HUNTS POINT INTERSTATE ACCESS IMPROVEMENT PROJECT – CONTRACT 3

PIN X731.65, Contract D900055

Addendum #8

July 22, 2022

INDICATIVE PLANS
WORK ZONE TRAFFIC CONTROL
STAGE 1-3
BRIDGE
SHEET 2

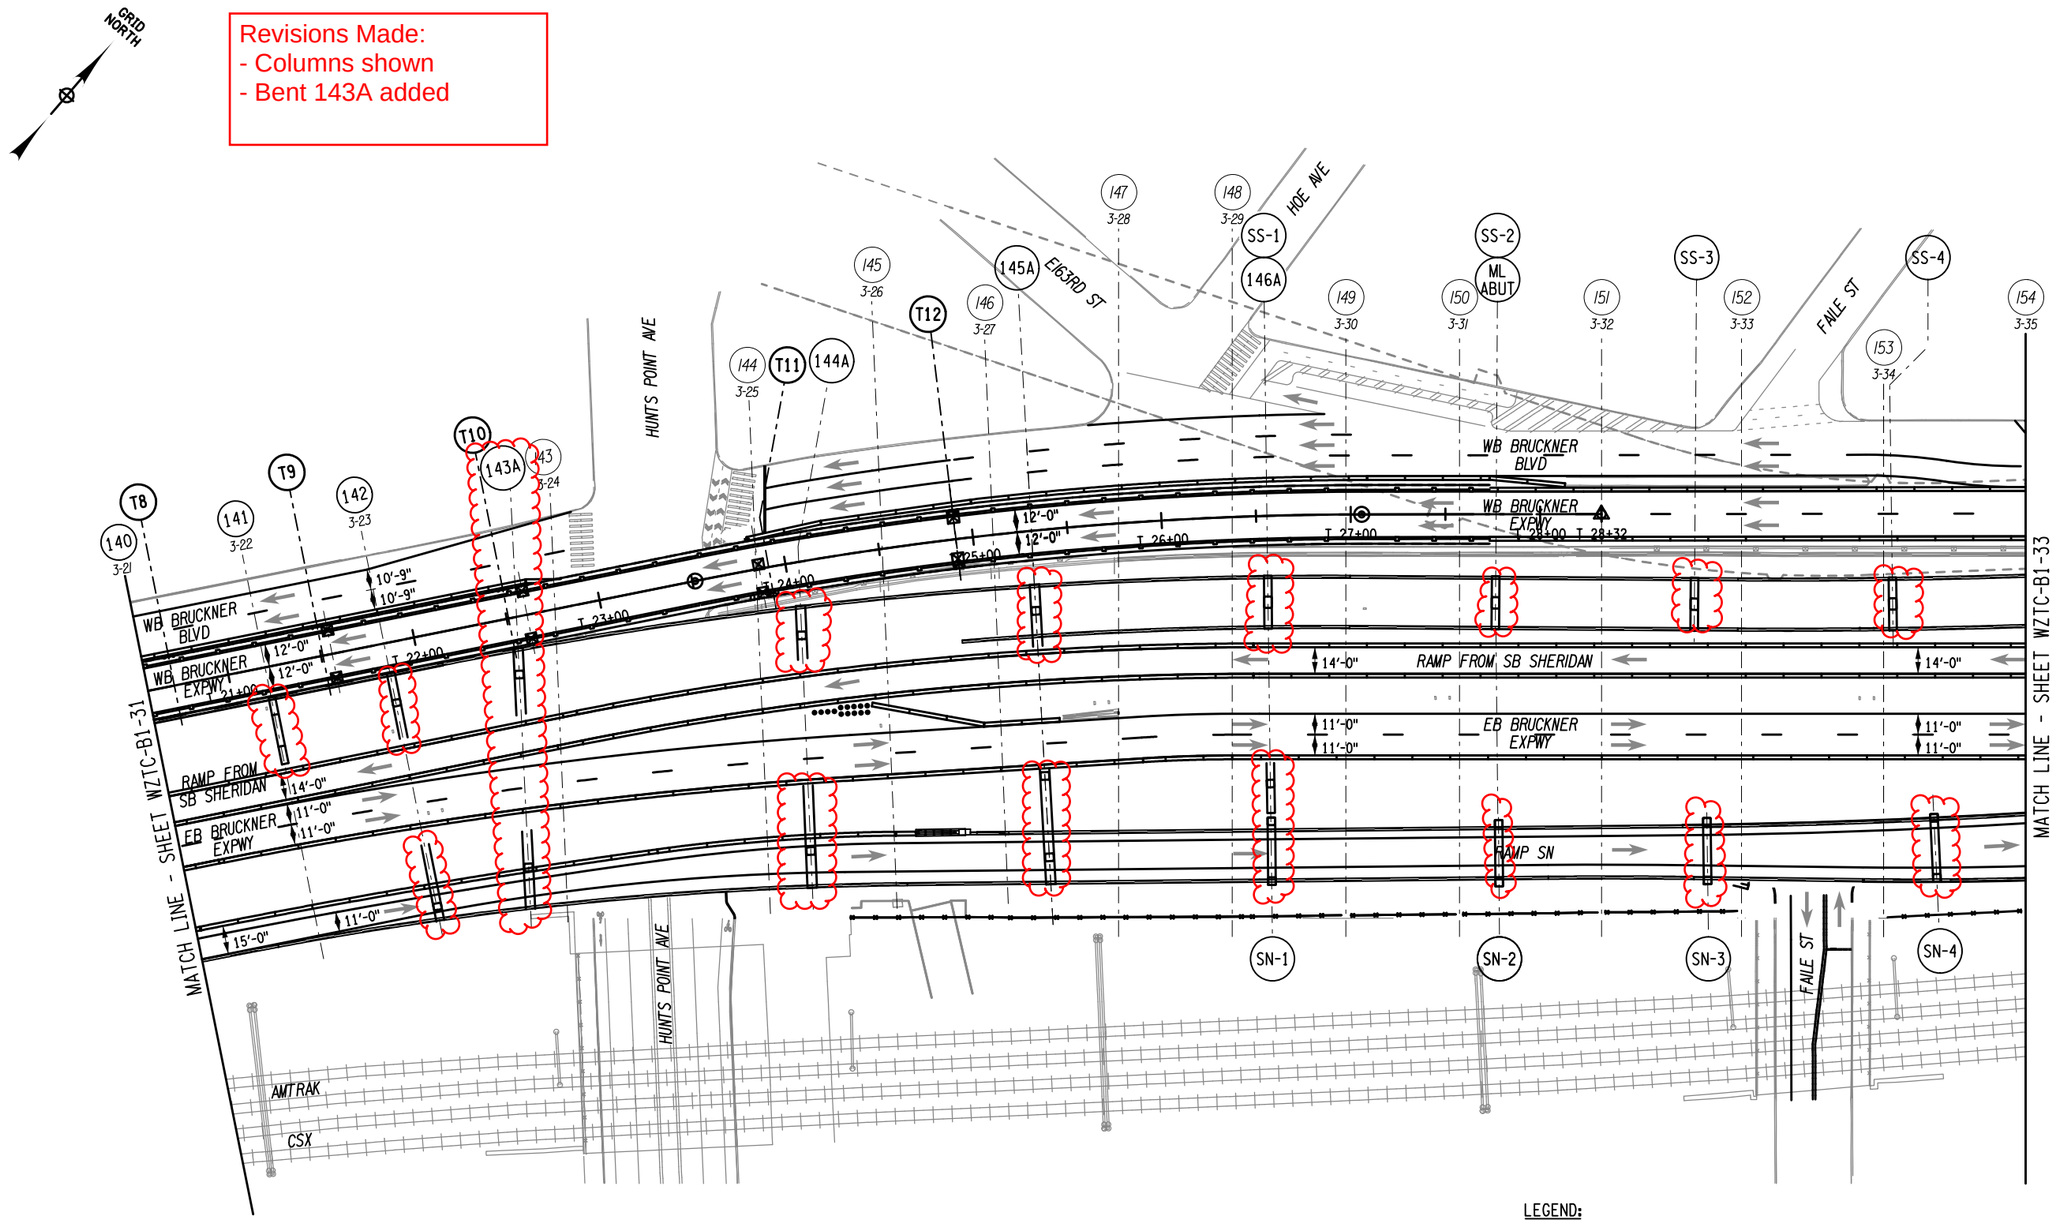
Revisions Made:
- Columns shown
- Bent 143A added

INDICATIVE PLANS
WORK ZONE TRAFFIC CONTROL
STAGE 1-3
BRIDGE
SHEET 3

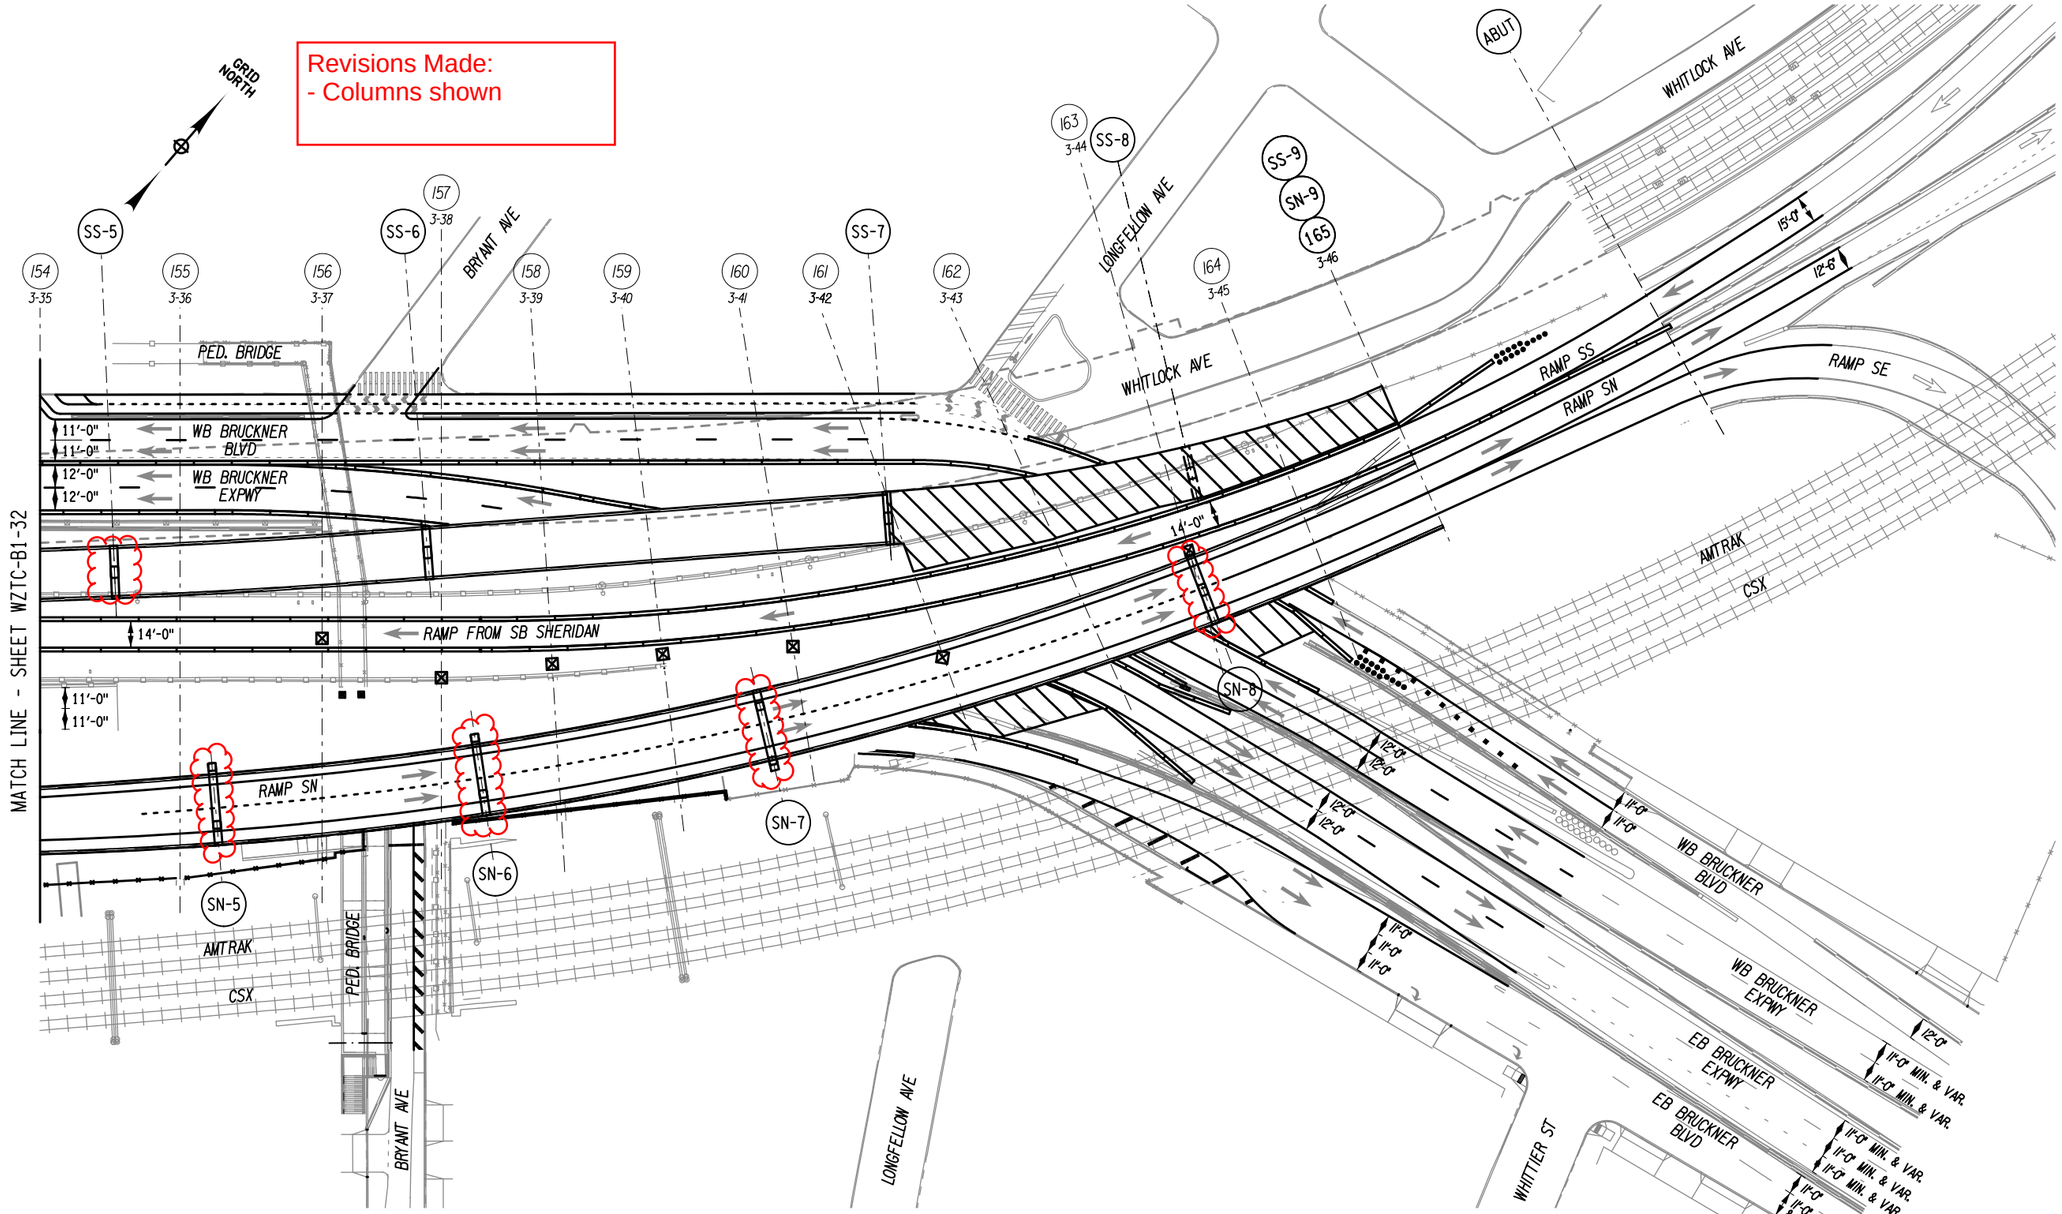
Revisions Made:
- Columns shown

INDICATIVE PLANS
WORK ZONE TRAFFIC CONTROL
STAGE 2
BRIDGE
SHEET 2

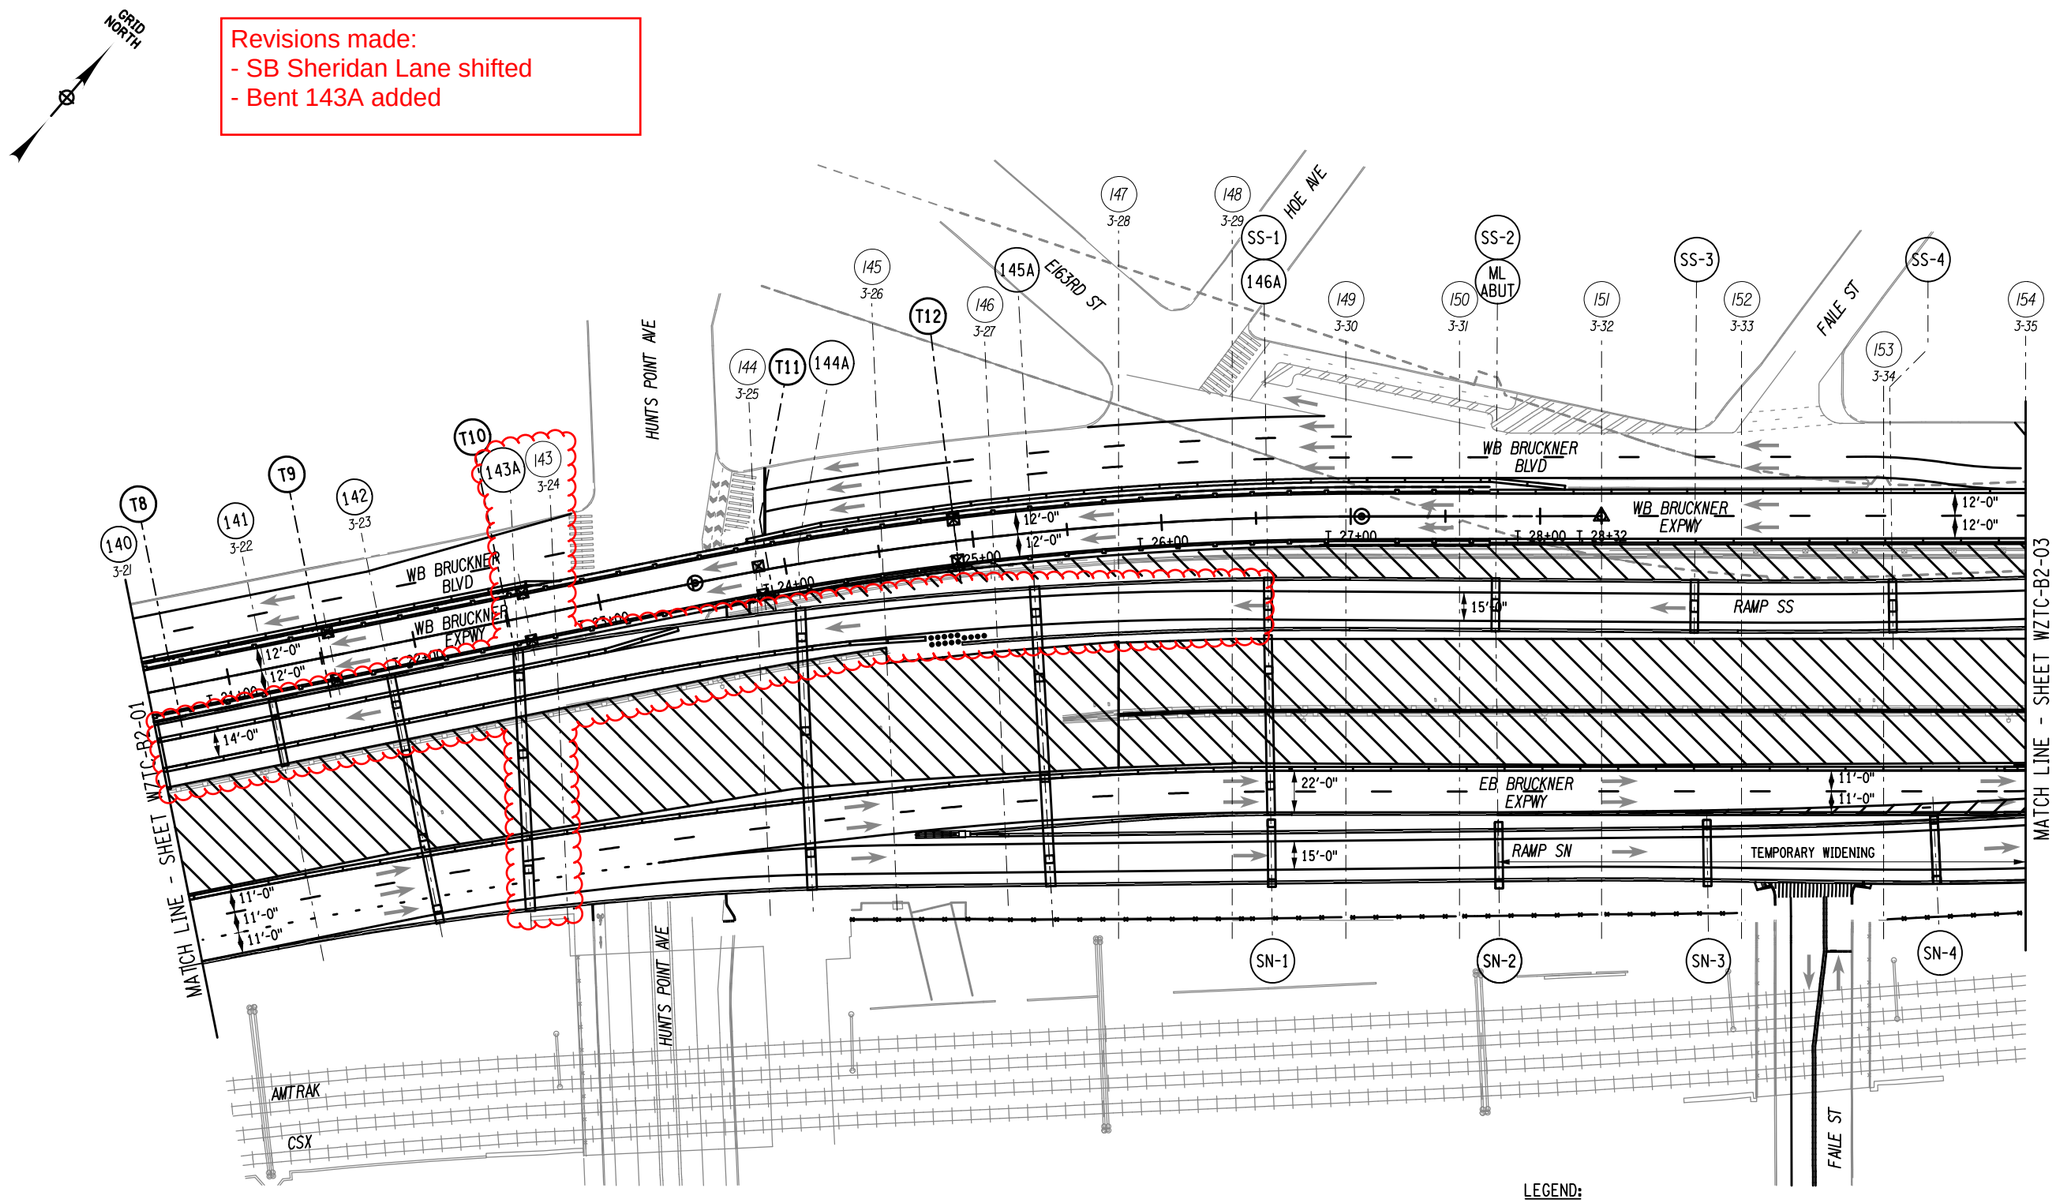
Revisions made:
- SB Sheridan Lane shifted
- Bent 143A added

INDICATIVE PLANS
WORK ZONE TRAFFIC CONTROL
AT-GRADE
STAGE 2
SHEET 2

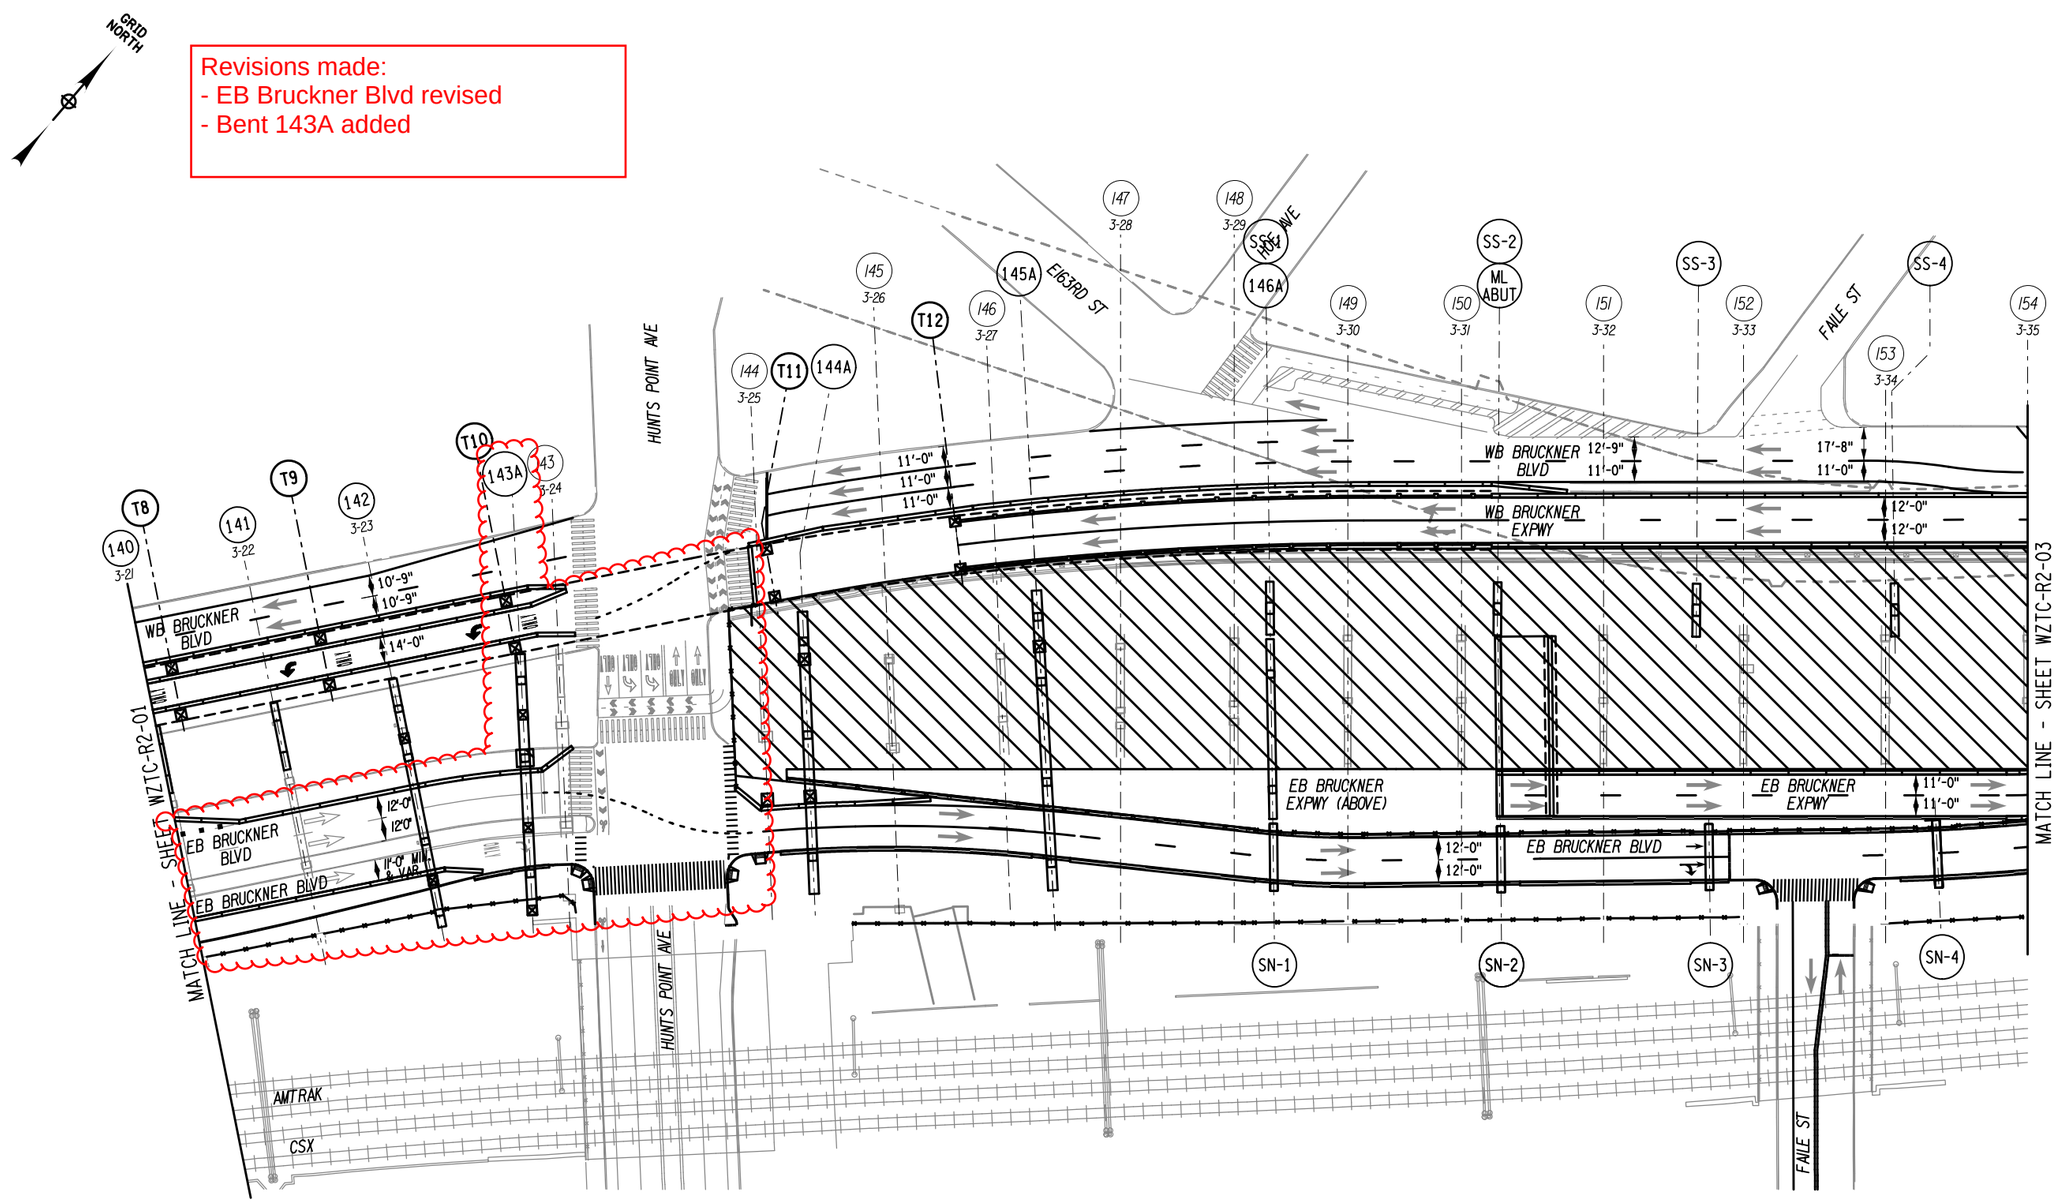
Revisions made:
- EB Bruckner Blvd revised
- Bent 143A added
